ADDENDUM NUMBER ONE (1)

Project: Ridgeland City Hall
City of Ridgeland
PN: 14084

FROM: Dean and Dean/Associates Architects, P.A.
4400 Old Canton Road, Suite 200
Jackson, MS 39211
(601) 939-7717

Sheet Number :
C4.11

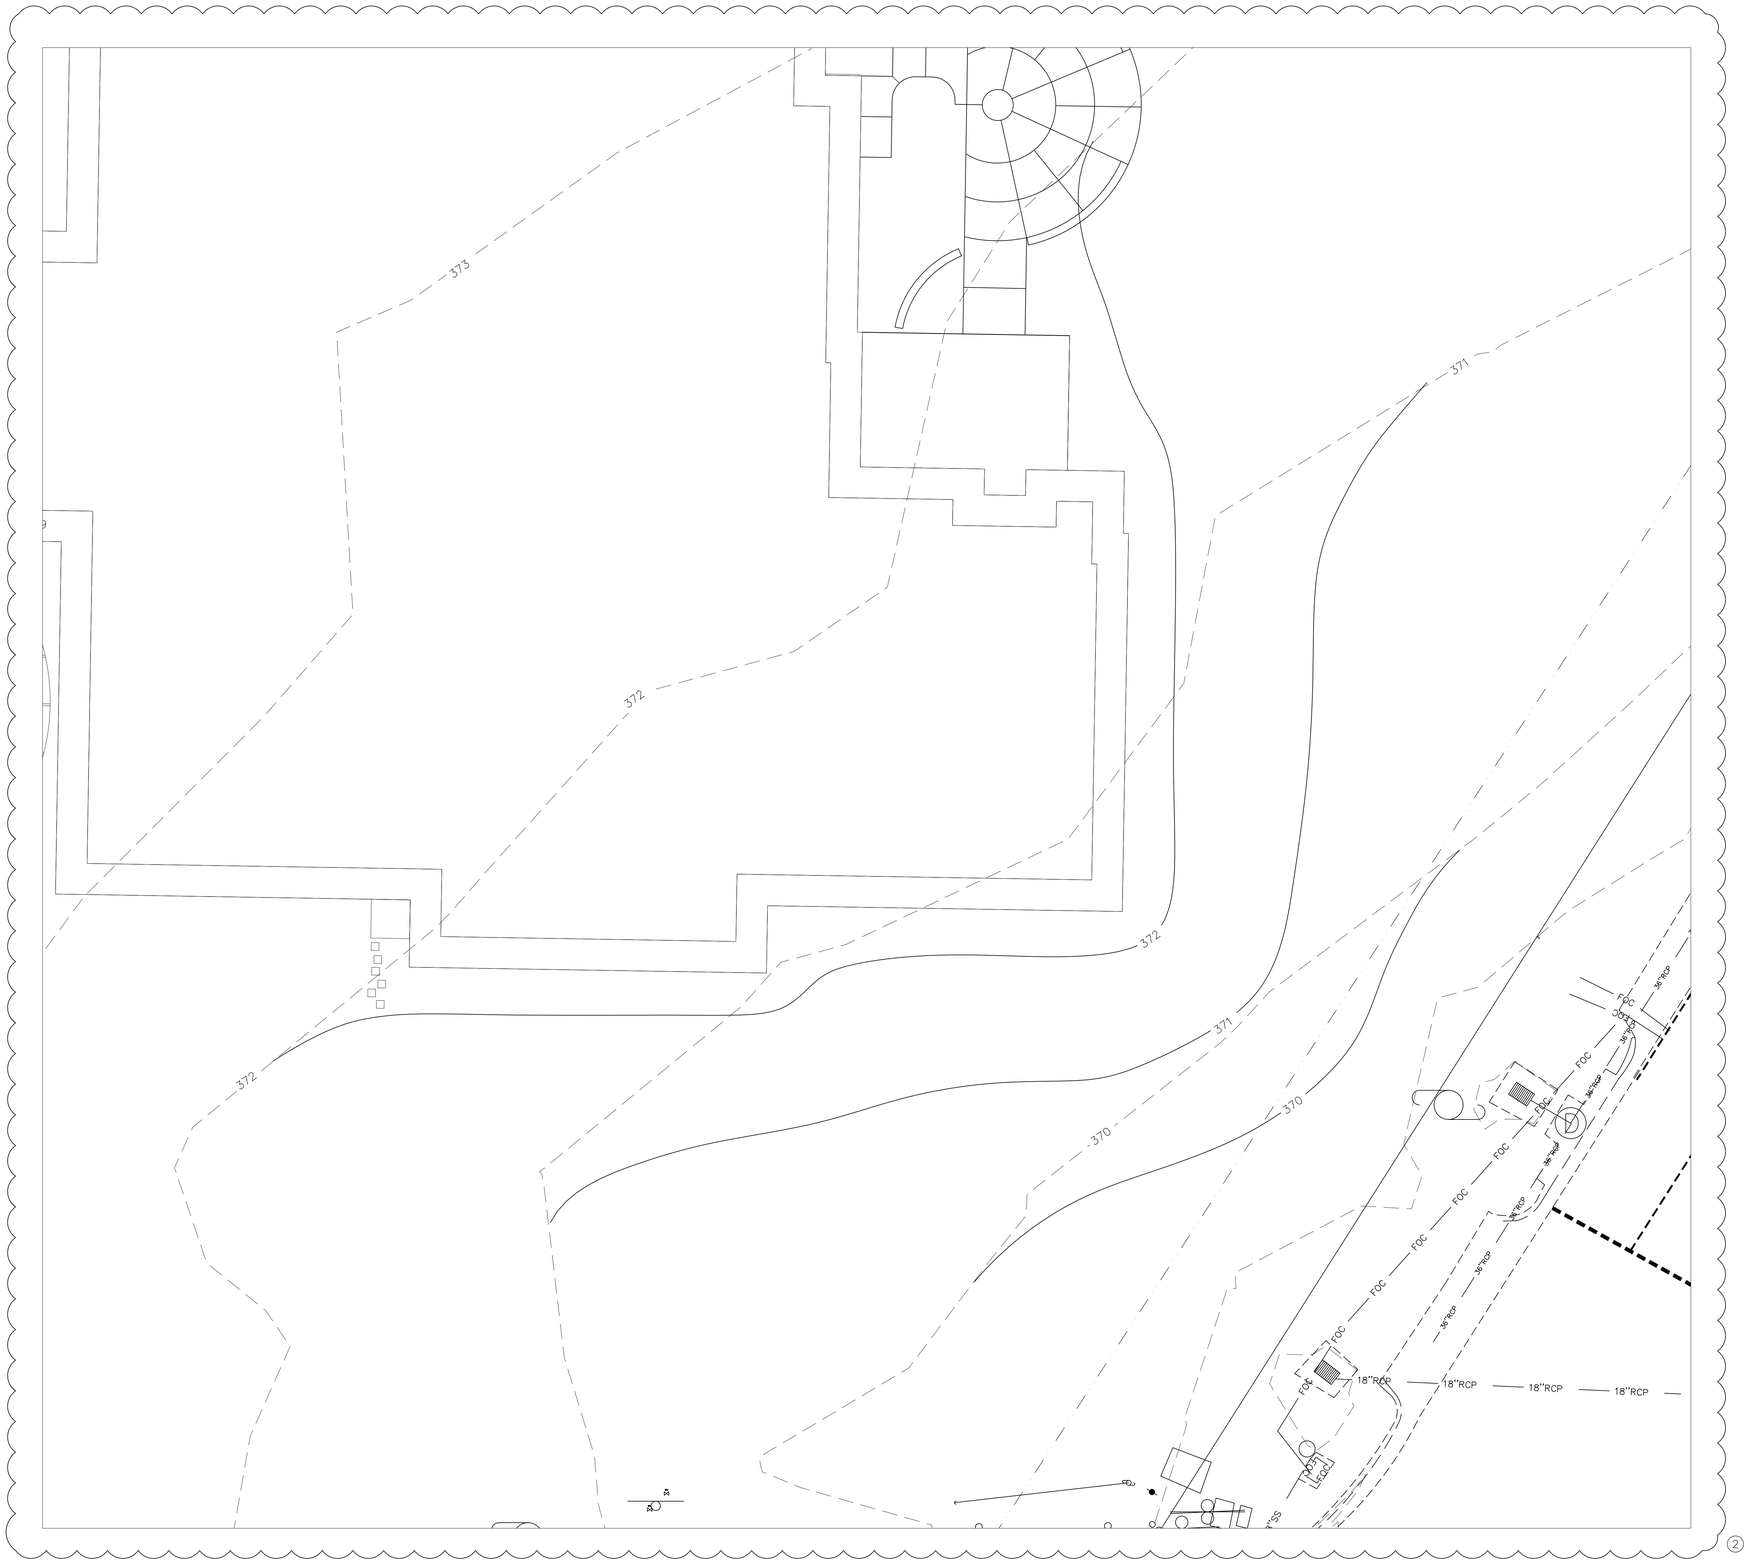
1. Note was added: "Refer to Sheet L100A for Grades at Building"

Sheet Number :
C4.12

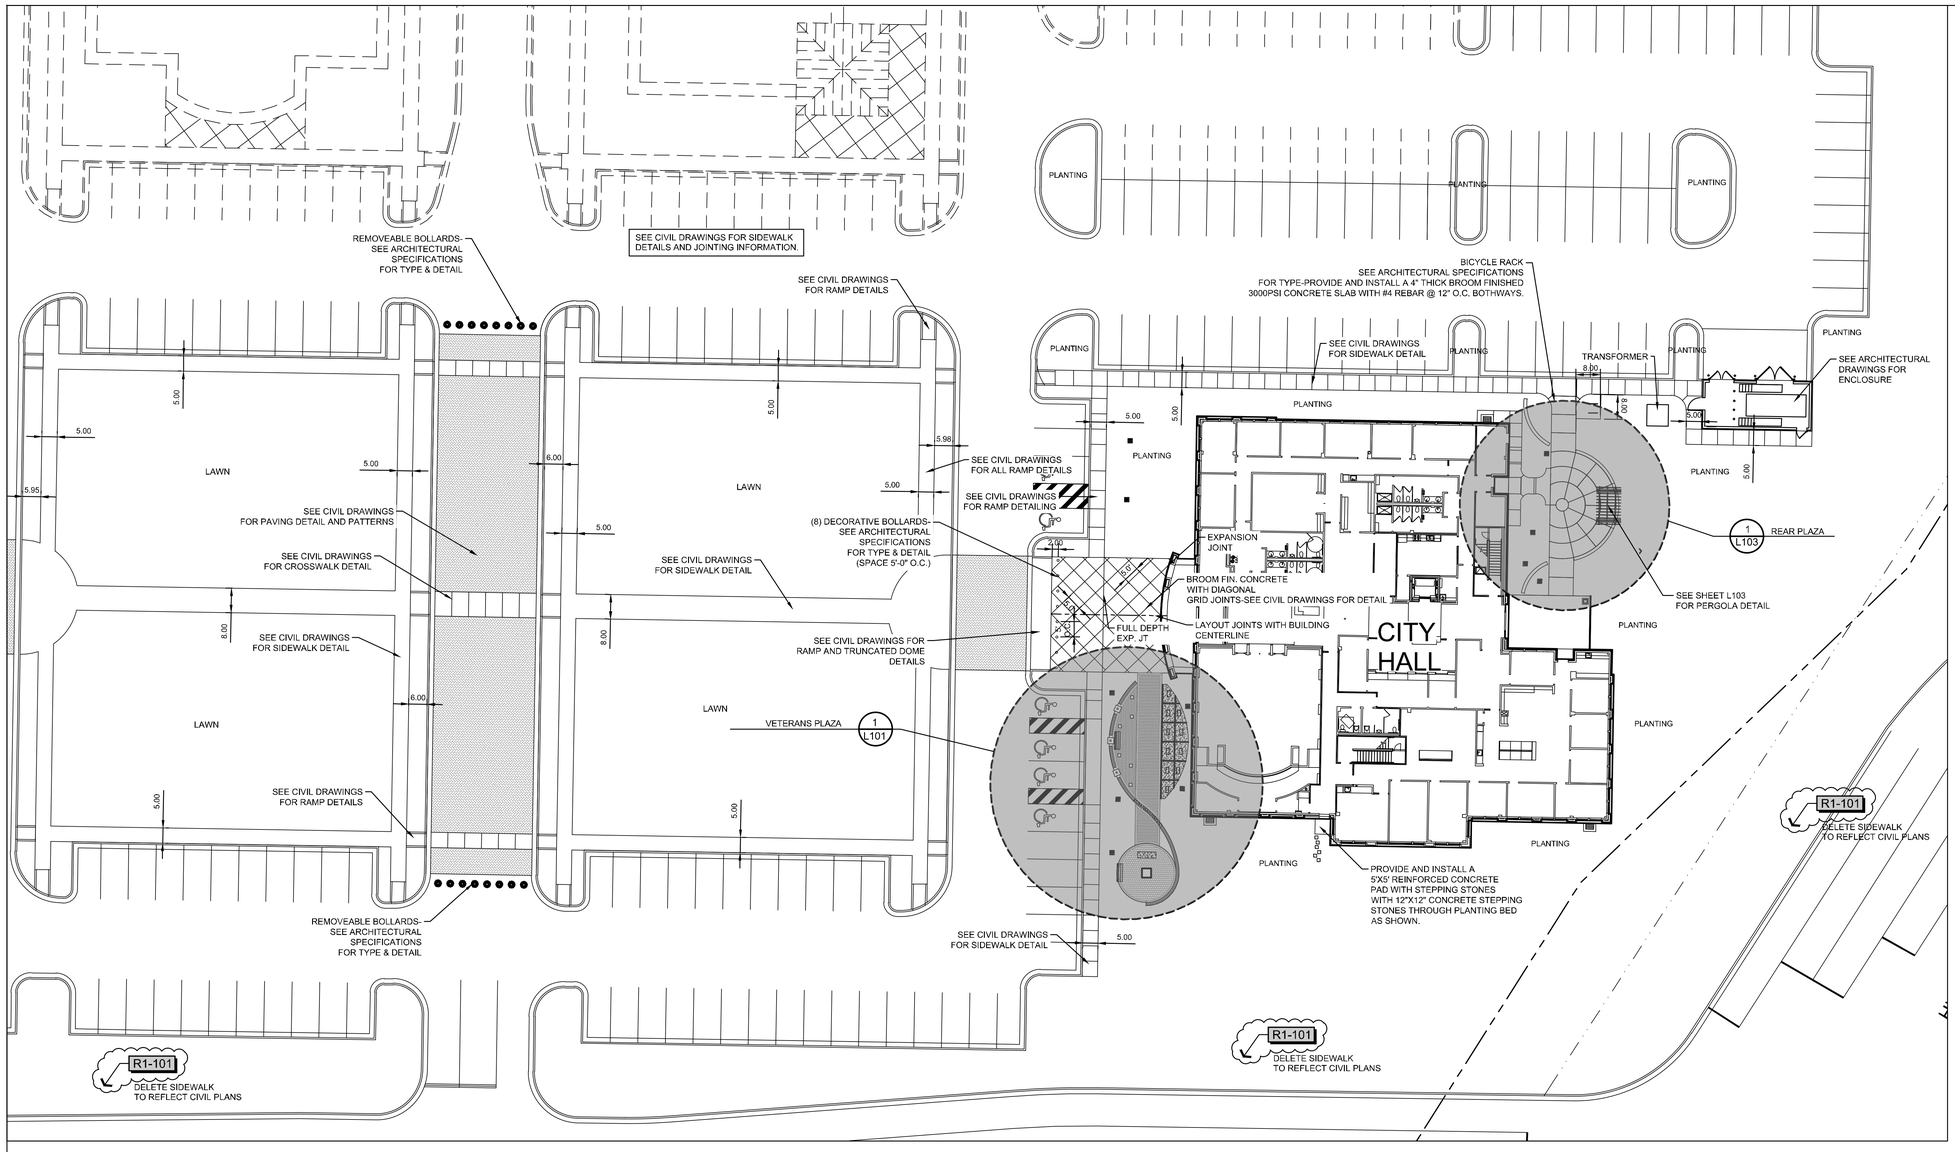
1. Note was added: "Refer to Sheet L100A for Grades at Building"
2. View of contours around building was adjusted to match the Grading Detail Index on Sheet C4.12.

9 S201 3/4" = 1'-0"

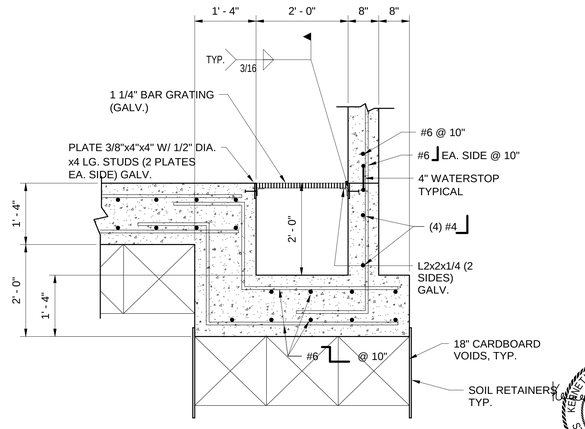
Item No. 7 Ref. Sheet S201, detail 9 – Add note "Top of grade beam varies, bottom of grade beam shall be as shown, -5'-0" from F.F." See attached sheet S201.

1 / E6.1 ROOF PLAN – ELECTRICAL
SCALE: 1/8"=1'-0"

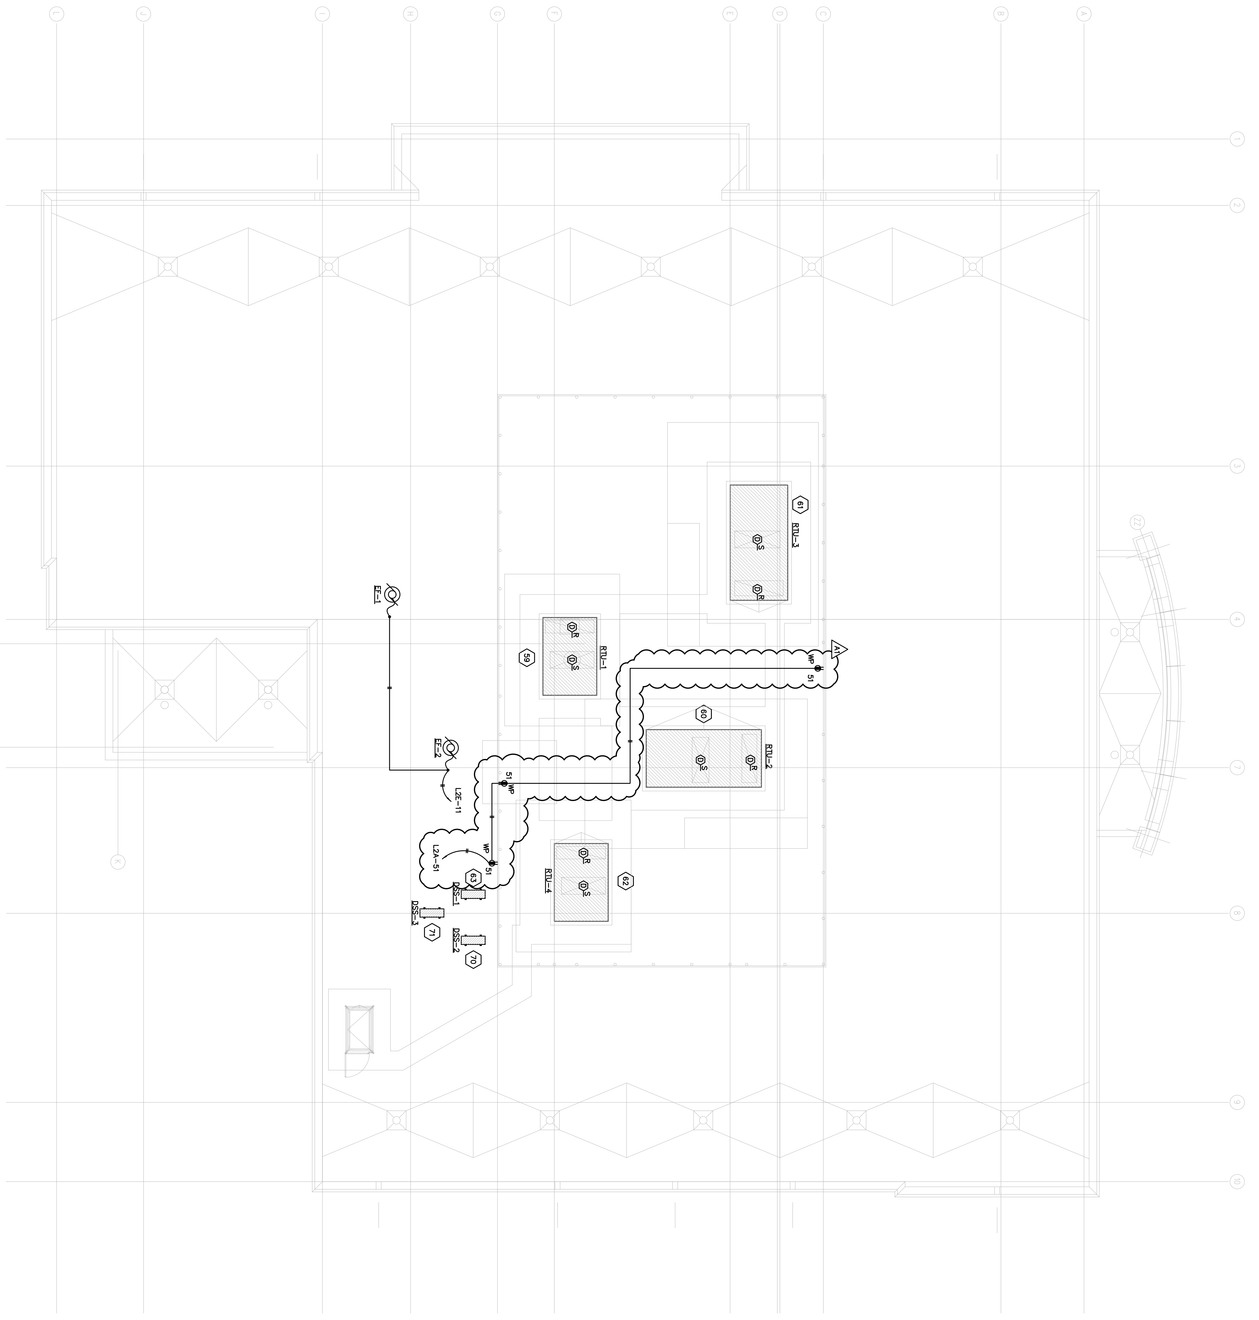
1. Provide three weatherproof receptacles near mechanical units on the roof and connect to circuit L2A-51.
